FAILURE OF SPRINKLER SYSTEM IN HIGH RISE BUILDING

I. INTRODUCTION

We have investigated the cause of **Failure of the gasket** at the bottom flange of a Filter unit located at the 18th floor causing damage to four (4) elevators

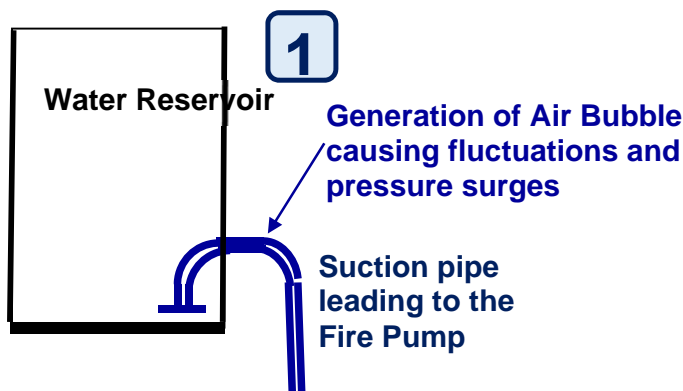
Probable Disturbances in the Pumps operation (Photo 1): The suction pipes arrangement promote the generation of large air bubble not in accord with NFPA 20 (item 4.14.6.1).

The air bubble may generate pressure surges in the pumps operation.

We mentioned above “Pressure Surges”. The probable cause of it is the way the pumps’ suction pipe connection to the water reservoir is installed. Large “air bubble” are created due to violation of the NFPA-20 instructions (see sketch in Pg. 2). This causes intermittent disturbances in the operation of the fire pump.

The designer plan of the Pump room and the reservoir is presented in the following page (**Photo 2**). The details of the suction pipe arrangement is poor.

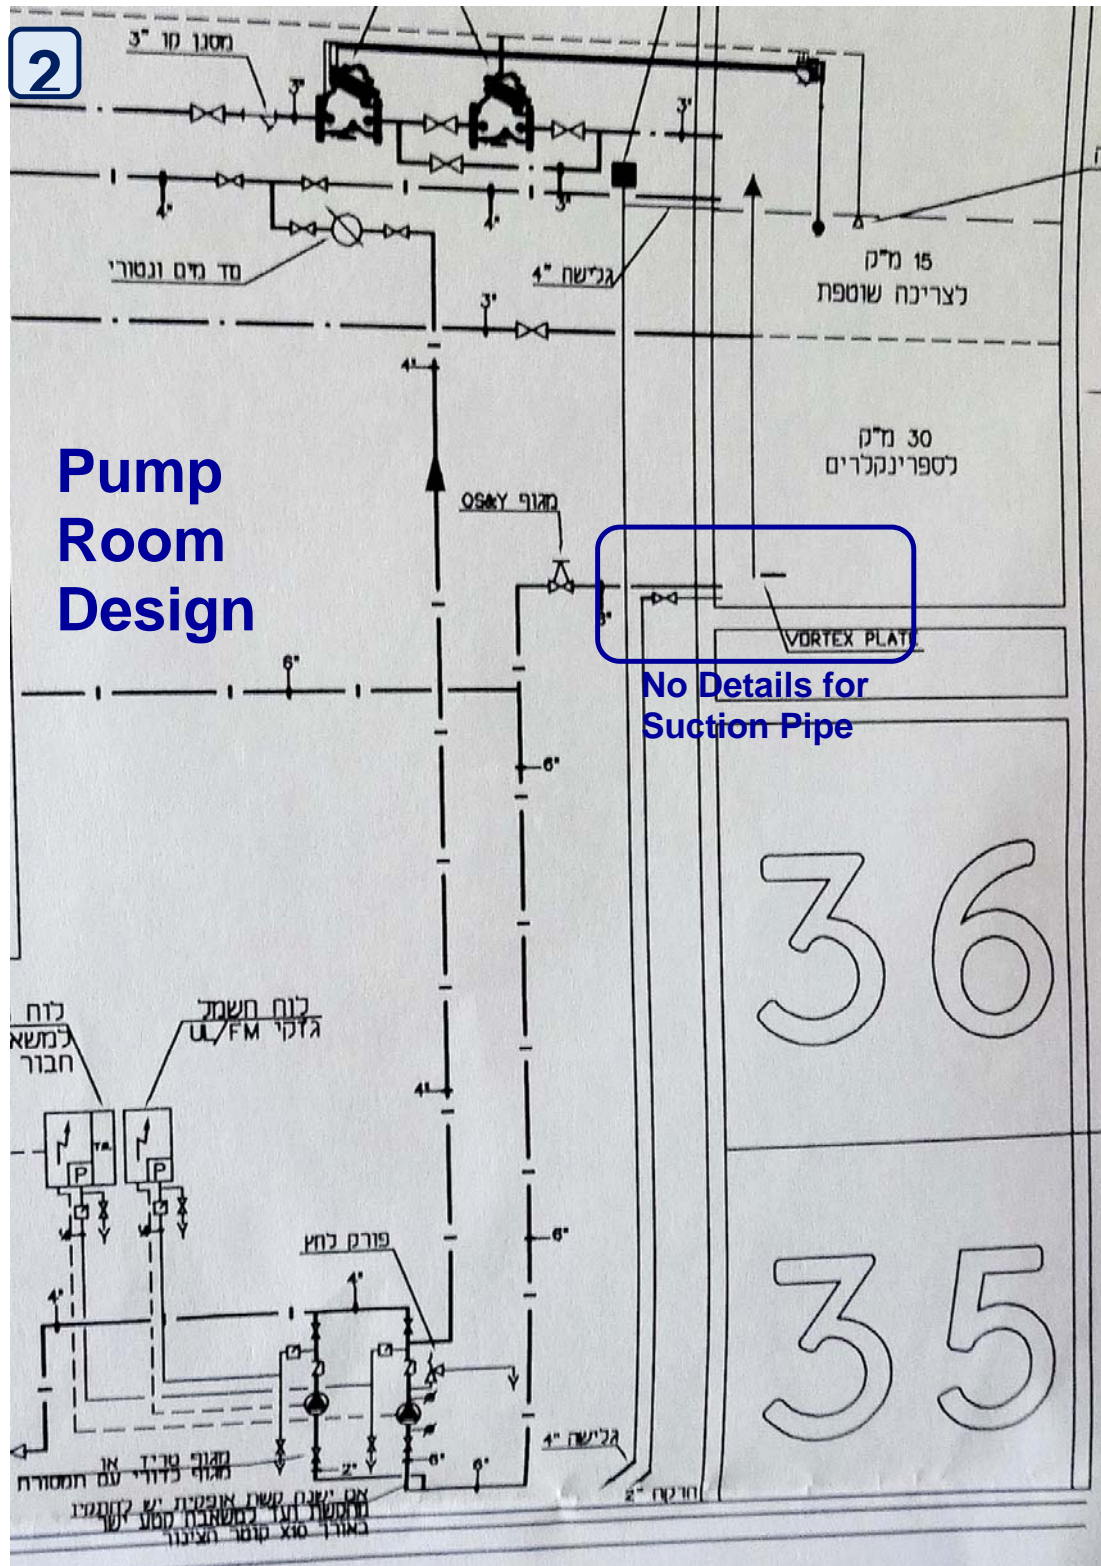
1. A flange connection failed in the 18th floor.
2. We conclude that the Contractor is responsible for the failures.
3. The pump suction arrangement is not in-line with the standard requirement. The design plan is vague, namely, no details were provided by the designer.

Photo 4 below present the flange after the repair.

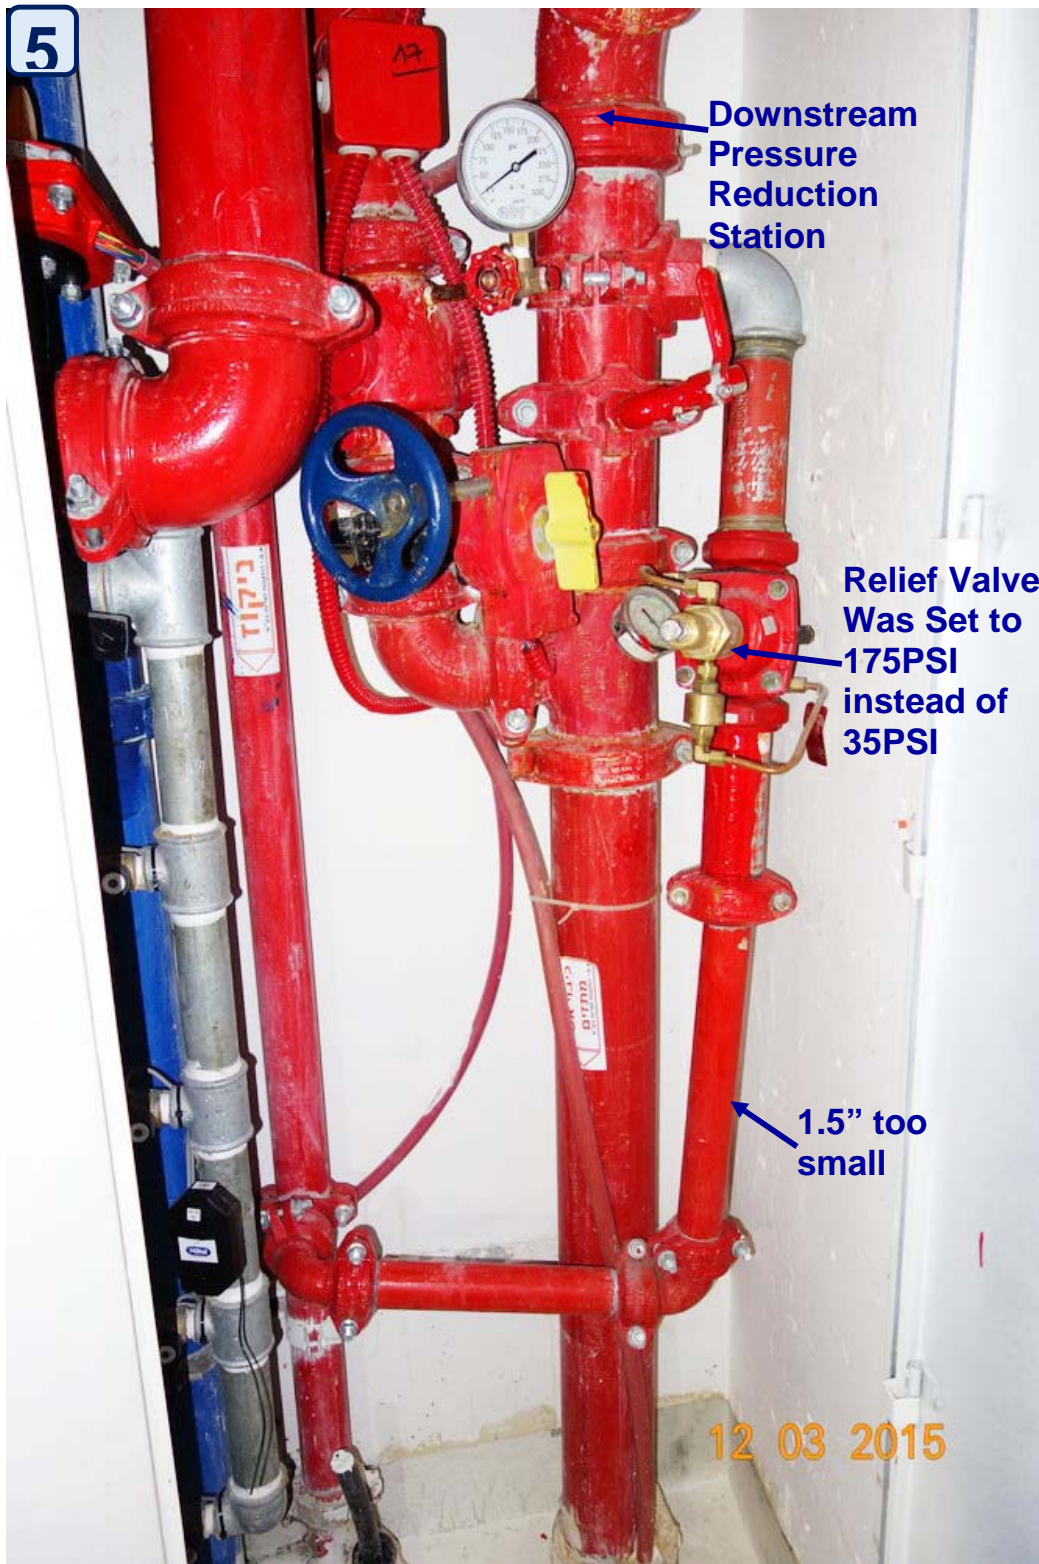
We were informed that it was reinserted with an addition of another gasket and the flanges were re-bolted. This is not the right method. It is necessary to install a good quality gasket suitable for 35 bars service.

We believe the failure of the flange is due to the use of a wrong type of gasket and uneven bolting of the flanges.

6. The Contractor reported that the original seal was made just of rubber. He added another rubber seal to the failed seal, a procedure that would promotes the recurrence of the failure.

However, the designer accepted lower pressure Class 150 accessories suitable for low-pressure service (**photo 6**).

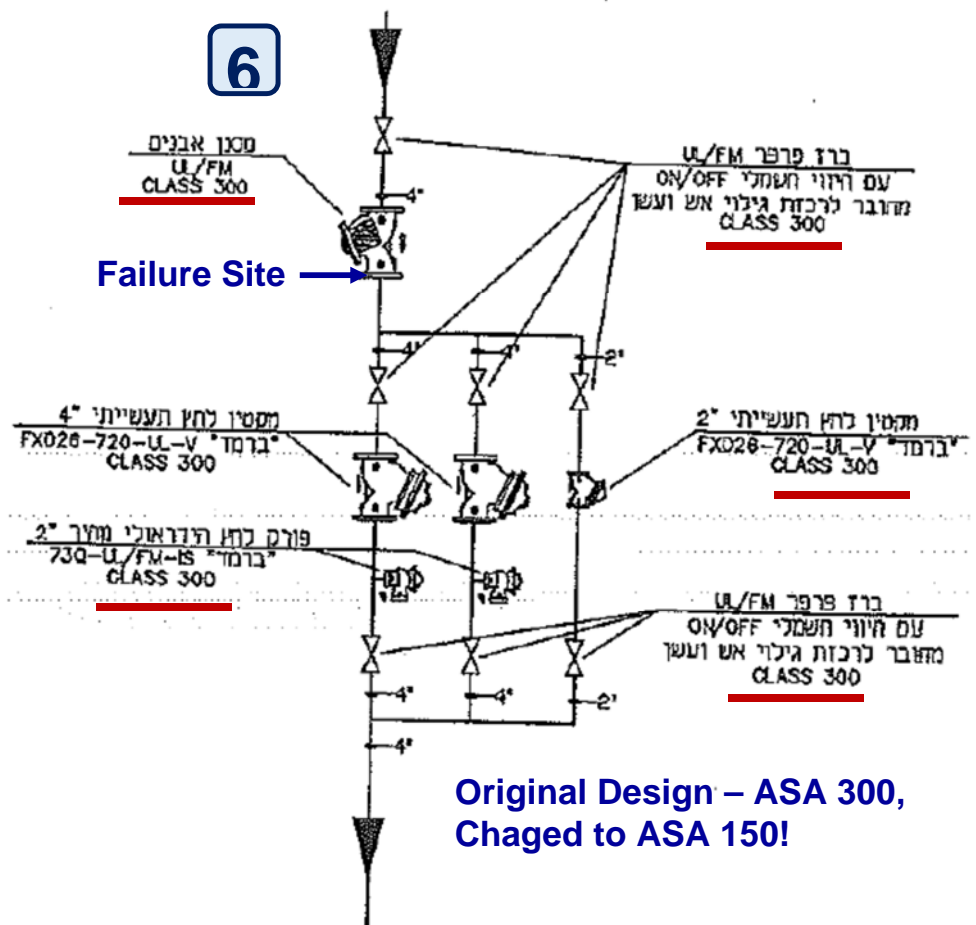
It appears that the Designer specified equipment (valves, pressure reducers and filter) as per ASA Class 300 that is suitable for high-pressure service.

8. The designer is responsible for accepting lower pressure accessories (see item 5 above) in contrast with his original specification for high-pressure equipment.
